AGENDA
PLANNING COMMISSION
116 WEST NEEDLES
BIXBY, OKLAHOMA
March 17, 2014 6:00 PM

**MINUTES
PLANNING COMMISSION
116 WEST NEEDLES
BIXBY, OKLAHOMA**

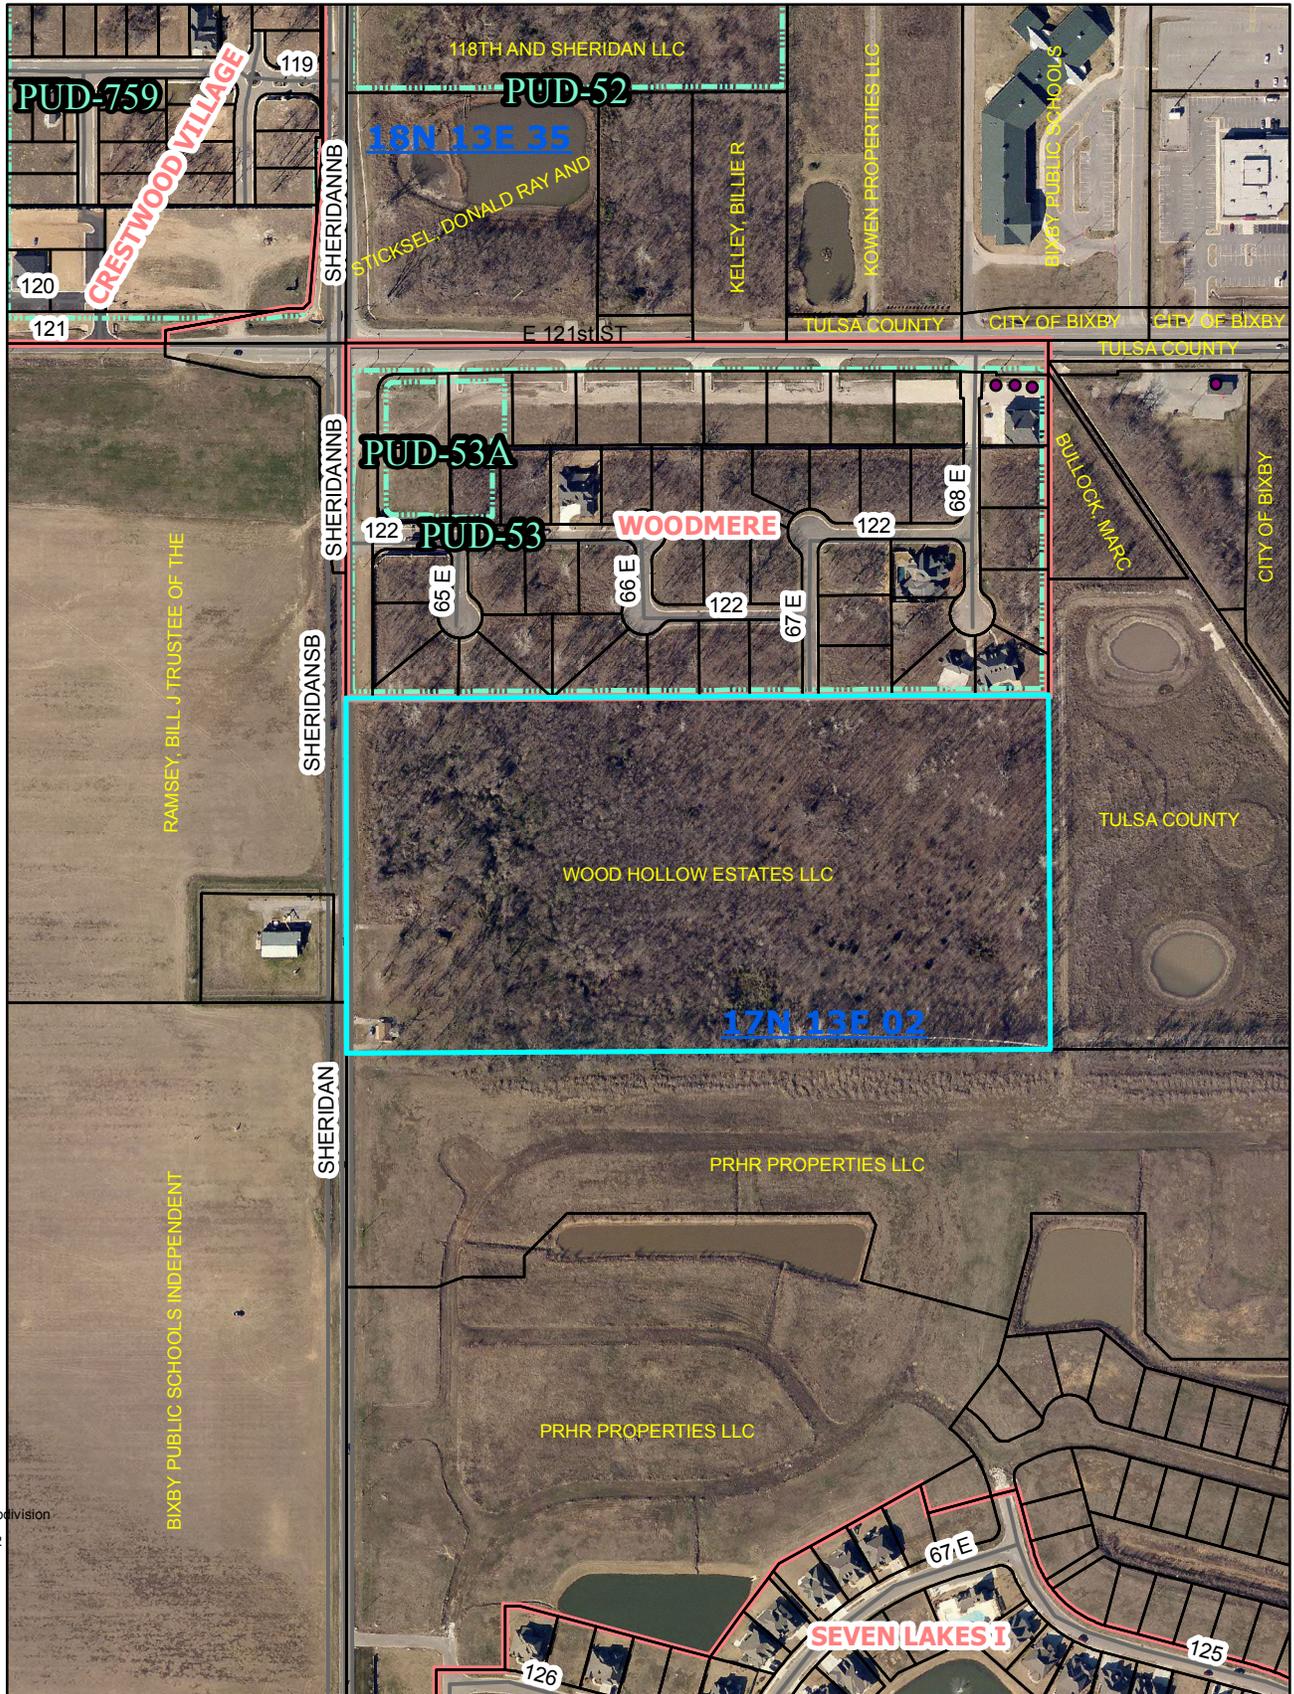
Since the Preliminary Plat, the entrance street has been widened. See related recommendations in this report below.

The Final Plat indicates 10' Sidewalk Easements ("SWE") outside the 30'-wide Reserve A for private streets, in which 4'-wide sidewalks would be installed.

Staff Recommendation. Staff recommends Approval of the Preliminary Plat subject to the following corrections, modifications, and Conditions of Approval:

1. Subject to the satisfaction of all outstanding Fire Marshal, City Engineer, and/or City Attorney recommendations.
2. Subject to City Engineer and/or County Engineer curb cut approval for the proposed access points to Sheridan Rd., and the Fire Marshal's approval of locations, spacing, widths, and curb return radii.

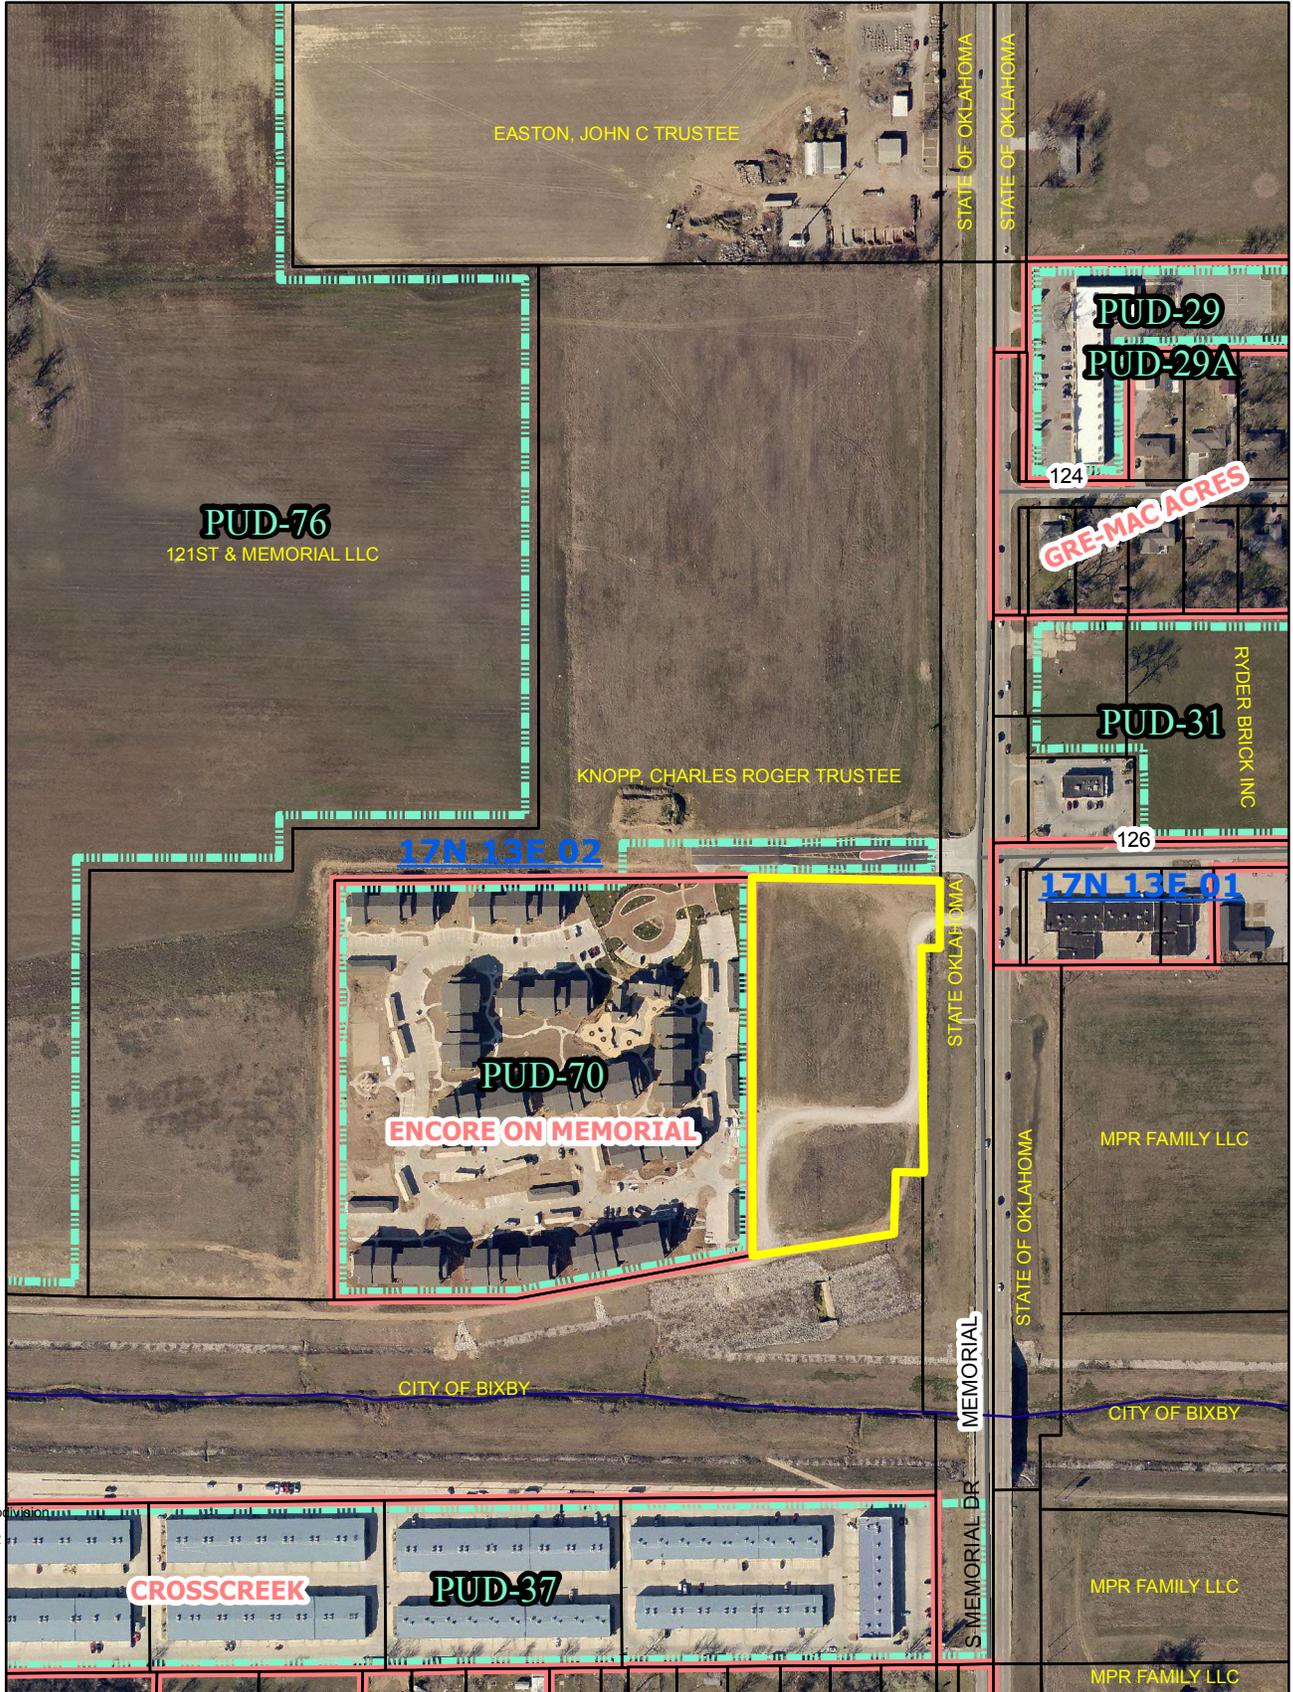
- d. 17.5' U/E label missing from along 57.86' plat boundary on Detail 1.
 - e. Angle/bearing and distance on Lot 1/2 common line.
 - f. Text/linework conflict at west line of Lot 1.

13. DoD/RCs: Does not provide for the formation of a property owners' association, such as would be made responsible for the MAEs and any other common features developed within the addition. At a minimum, please update DoD/RCs Section I.E to provide a formula for the respective maintenance responsibilities of the MAE (e.g. only responsible for that part located within lot boundaries, or an equal share between the four (4) lot owners, or a proportional share, etc.). Use of clear and immutable formula

- language on the face of the plat, versus buried in the DoD/RCs (which may be fairly easily amended and commonly without City approval) is recommended.

14. DoD/RCs Section I: Does not provide dedication language pertaining to the 10'-wide Trail Easement as represented on the face of the plat.
 15. DoD/RCs Section I.A: Please qualify this section as follows: "...nothing herein shall be deemed to prohibit properly-permitted drives, parking areas, ..."

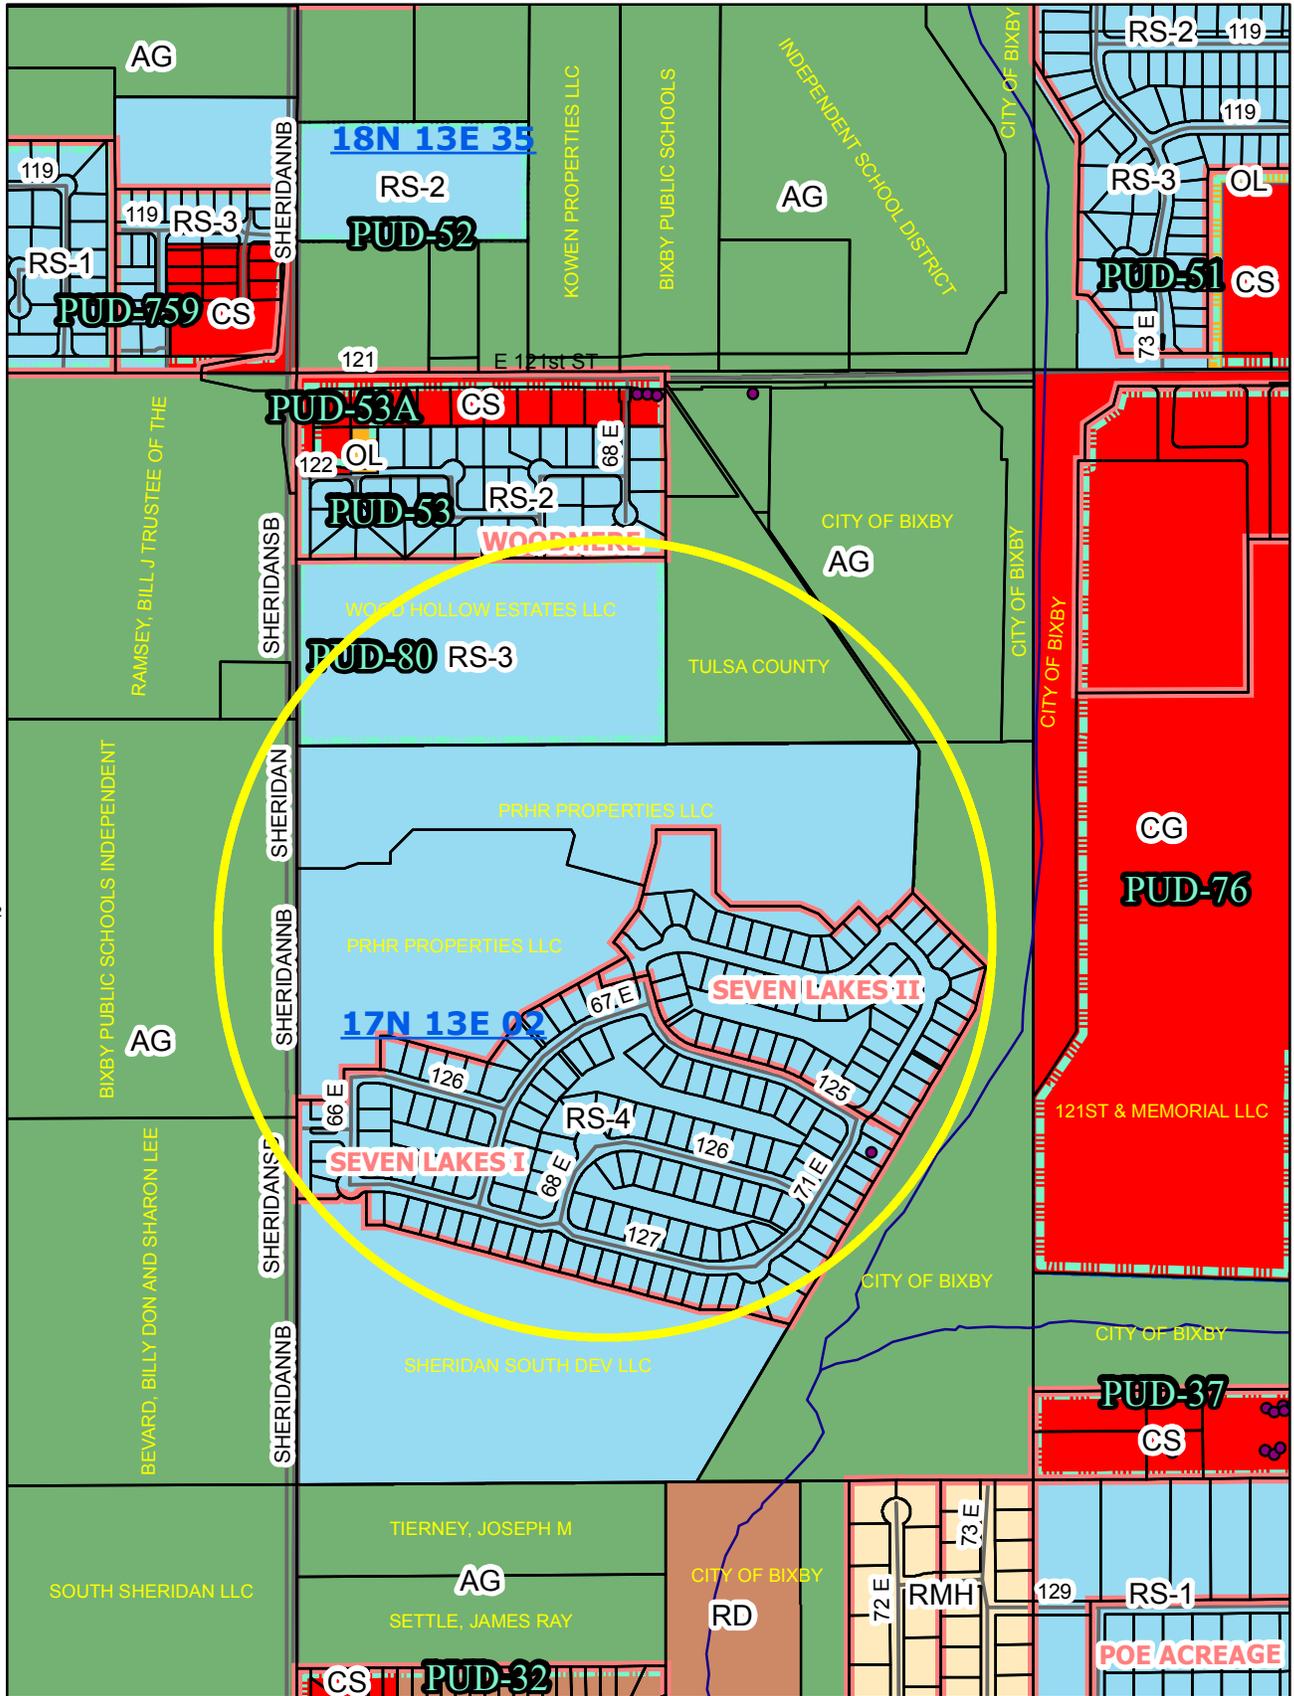
Lots in "Seven Lakes III" will utilize existing roadways as previously platted and constructed, with the exception of proposed Lot 6, Block 1. There is an existing temporary emergency-access drive through the north and northeast sides of this lot, which will be removed when the second permanent street connection to Sheridan Rd. is built. This second street connection will be contained within "Seven Lakes IV" and will provide a secondary means of ingress/egress for the entire Seven Lakes development.

Staff Recommendation. Staff recommends Approval of the Preliminary Plat with the following corrections, modifications, and Conditions of Approval:

1. Subject to compliance with all Fire Marshal, City Attorney, and City Engineer recommendations and requirements.
2. Per SRs Section 12-4-2.A.5, the Location Map must include:
 - All platted additions represented with the Section:
 - *Scenic Village Park* (missing)

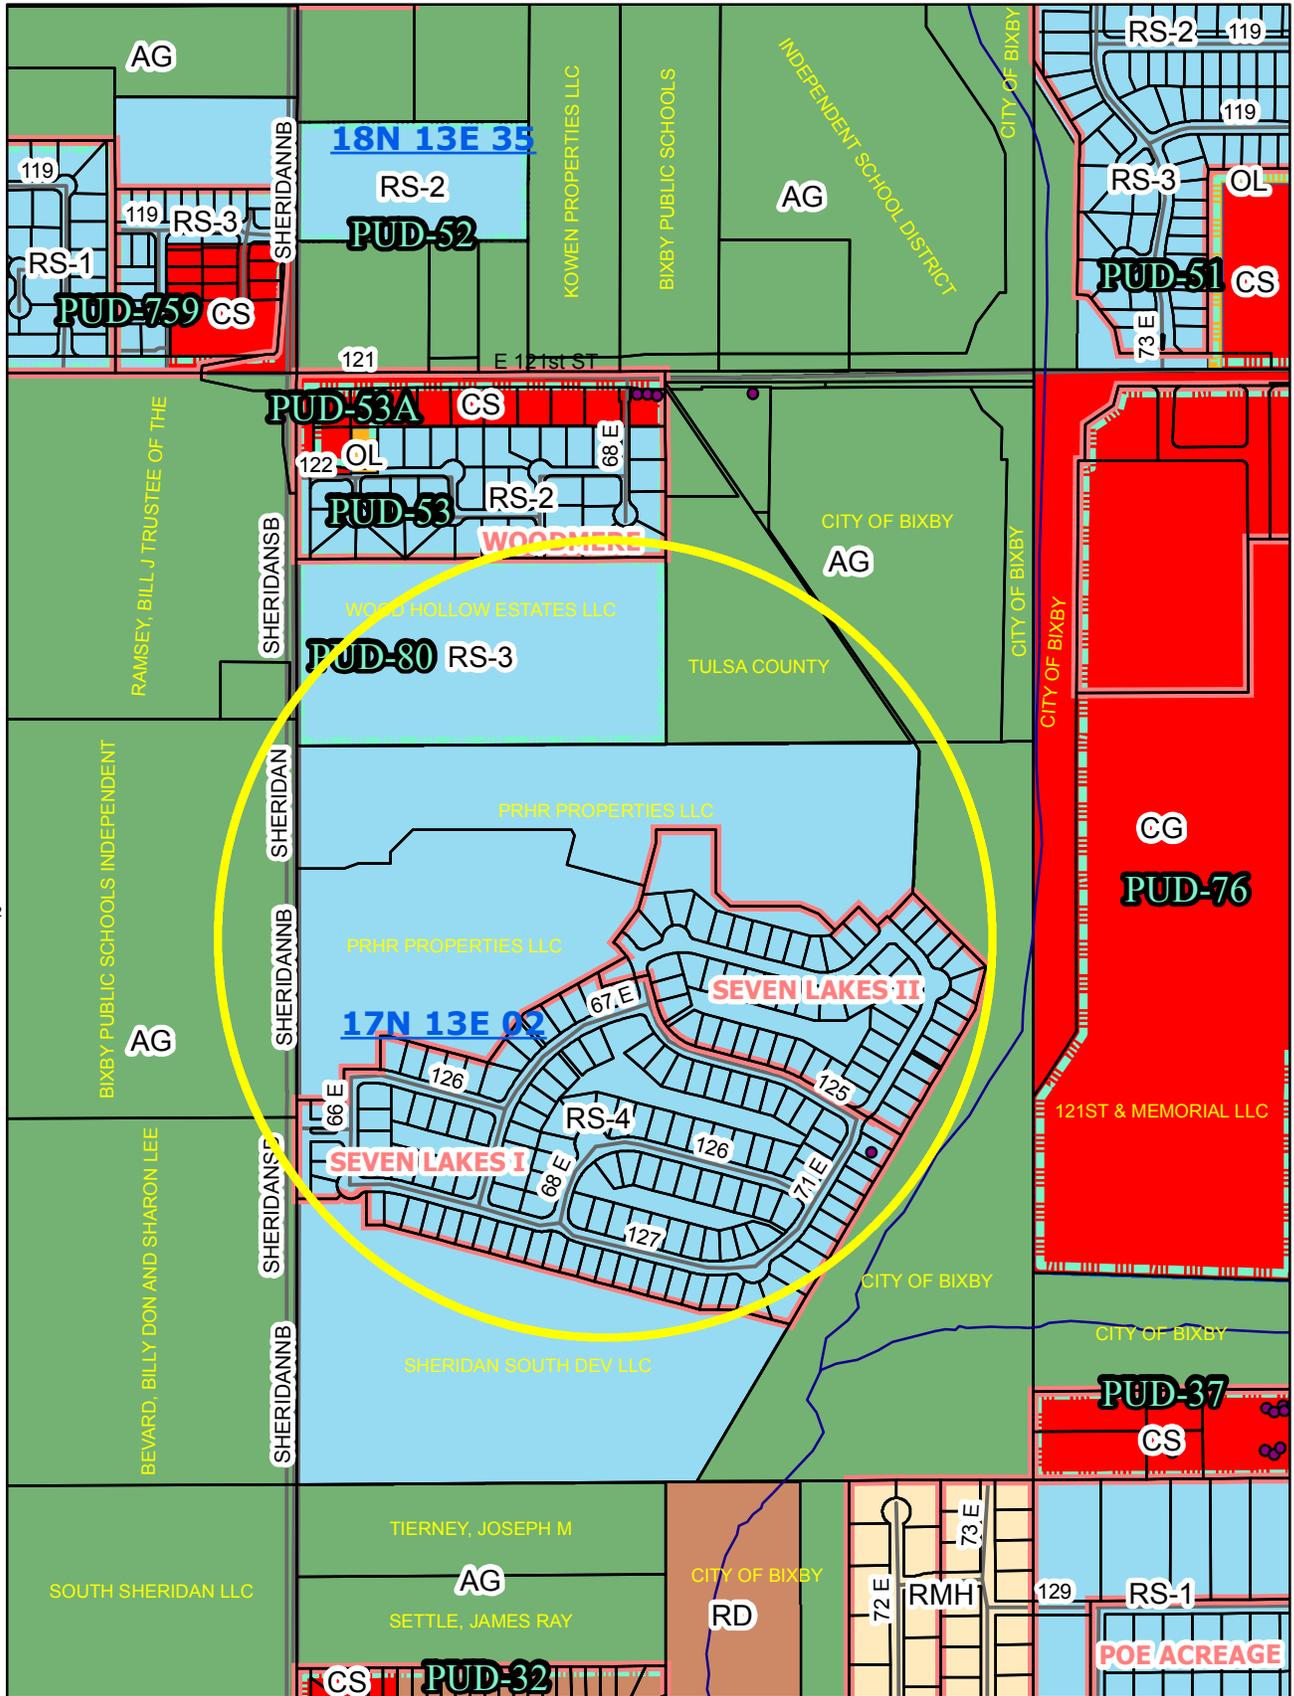
Access and Internal Circulation. Primary access to the subdivision would be via internal streets which ultimately connect to Sheridan Rd. A new entrance street will be constructed with this subdivision, recommended to be named E. 125th St. S. It is platted at a width apparently wider than the rest of those in the subdivision, but its width is not dimensioned. Together with 126th St. S., it will be the second means of ingress/egress serving the entire Seven Lakes development.

Staff Recommendation. Staff recommends Approval of the Preliminary Plat with the following corrections, modifications, and Conditions of Approval:

1. Subject to compliance with all Fire Marshal, City Attorney, and City Engineer recommendations and requirements.
2. Please relocate the "Unplatted" label from the Reserve Area B area of *Seven Lakes II*.
